To: Tedder, Newton[Tedder.Newton@epa.gov]
From: Civian, Frederick (DEP)
Sent: Wed 5/17/2017 5:28:32 PM
Subject: RE: ACTION - MS4 jurisdiction questions

From: Civian, Frederick (DEP) [<mailto:frederick.civian@state.ma.us>]
Sent: Tuesday, May 16, 2017 11:11 AM
To: Tedder, Newton <Tedder.Newton@epa.gov>
Subject: ACTION - MS4 jurisdiction questions
Importance: High

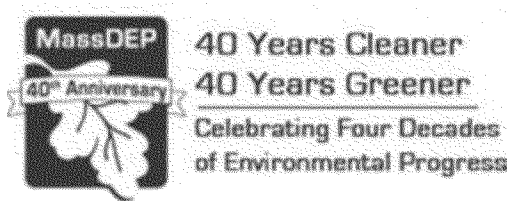
See the attached diagram . . . these hypotheticals are drawn from questions that arose with the Ct. River and the Cape Cod folks.

Outfall #1 collects runoff from a road inside the UA and discharges to a stream outside the UA . . . is it part of the MS4 system?

Outfall #2 collects runoff from a road outside the UA and discharges to a stream outside the UA .

. is it part of the MS4 system?

What about the reverse: an outfall collects runoff from outside the UA and discharges to a stream inside the UA?

Outfall #3 discharges to the ground, not to a surface water . . . is it part of the MS4 system?

The Town's transfer station is outside the UA . . . is it subject to the MS4 permit . . . i.e., does it need a SWPPP?

Outfall 1 – MS4 permitted outfall

Outfall 2 – not an MS4 permitted outfall

Reverse – MS4 permitted outfall

Outfall 3 – not an MS4 permitted outfall

Transfer station – not covered
